Midway City Council
20 April 2021
Regular Meeting

Rising Ranch Subdivision /
Preliminary Approval

CITY COUNCIL MEETING STAFF REPORT

Subject: Rising Ranch Subdivision – Preliminary Approval

RISE RANCH PRELIMINARY SITE PLAN
UDOT HOMESTEAD DRIVE ACCESS EXHIBIT
A SINGLE FAMILY RESIDENTIAL SUBDIVISION
LOCATED IN THE NORTHWEST 1/4 OF SECTION 34, TOWNSHIP 3 SOUTH, RANGE 4 EAST, SLBAM, MIDWAY, WASATCH COUNTY, UTAH

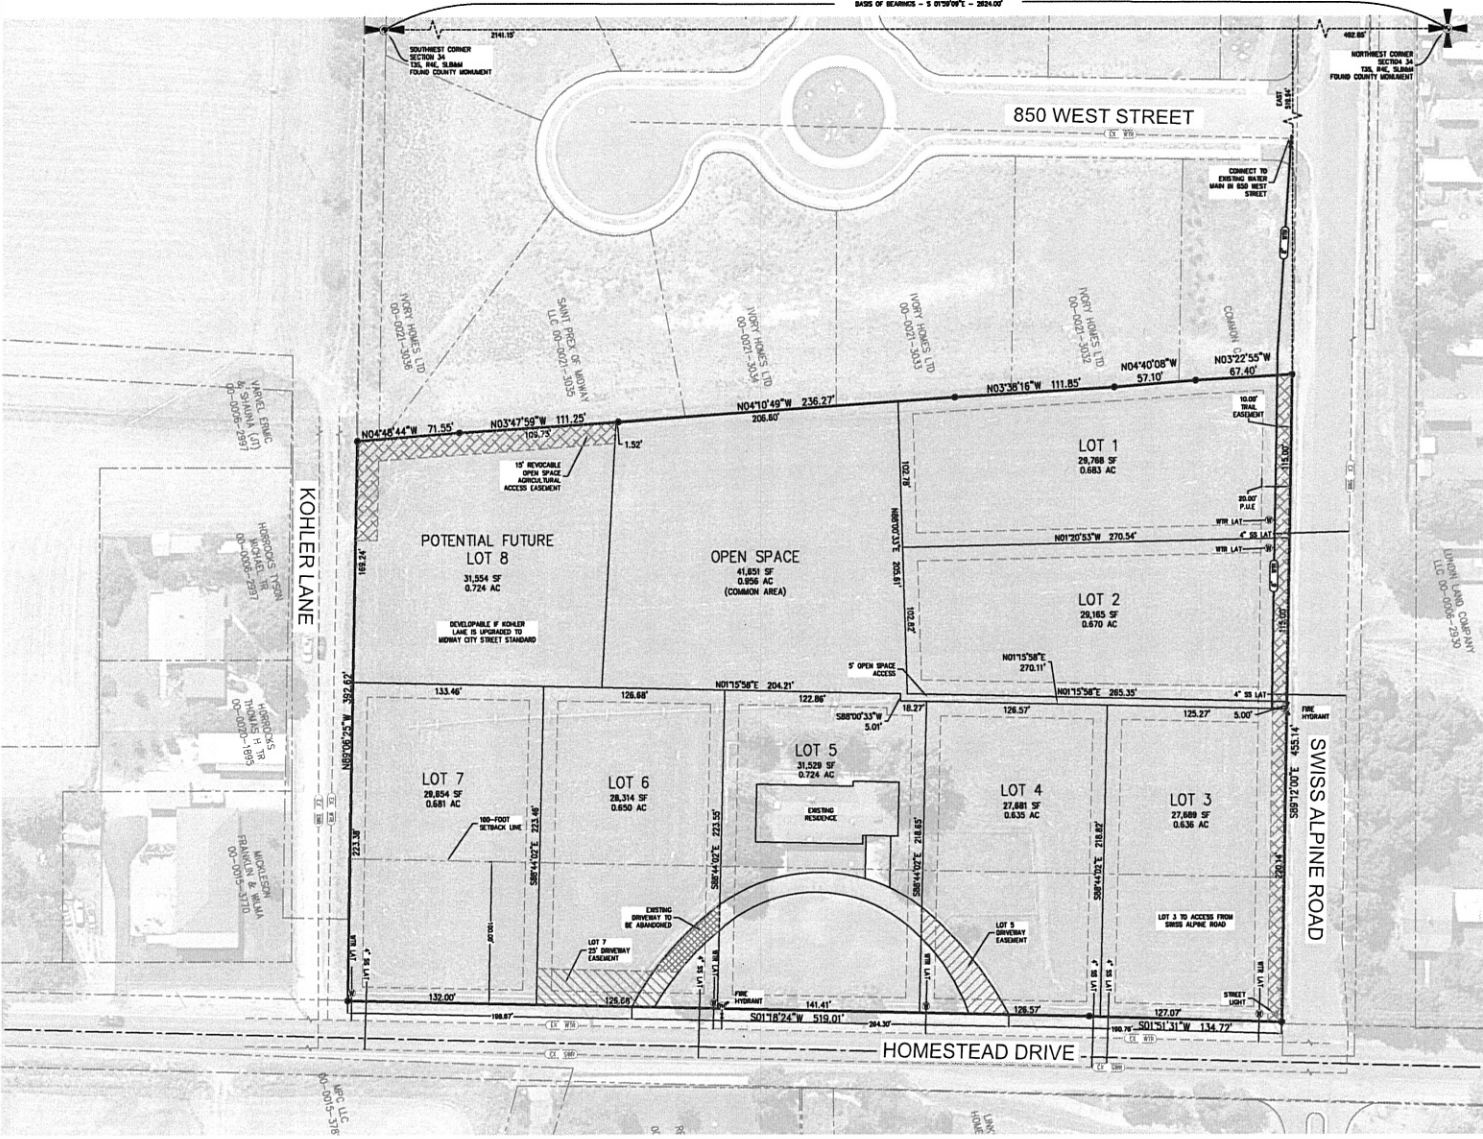
- The proposed development will be served from the Alpenhof Pressure Zone.
- Lots 1 and 2 will require a new 8" line be installed from the intersection of 850 West and Swiss Alpine Road. The proposed 8" line will terminate on lot 2.
- Lots 3 – 7 will be serviced off the existing culinary water line located within Homestead Drive.
- Will utilities be installed to the future lot 8?

- The proposed development will not construct any new roads, lots 1 – 3 will front Swiss Alpine Road and lots 4 – 7 will front Homestead Drive.
- Lot 4 and 5 will have a shared driveway and lots 6 and 7 will share a driveway access.

- It is proposed that the development install a detached 8' public trail adjacent to Swiss Alpine Road. This trail will connect onto the trail from St. Prex subdivision and terminate at Homestead Drive.
- The development shall participate funds into the Midway City General Trail Fund for the equivalent of a 5' bike lane across the frontage of Homestead Drive.

- The existing shoulder and borrow ditch will accommodate the storm drain for this subdivision.
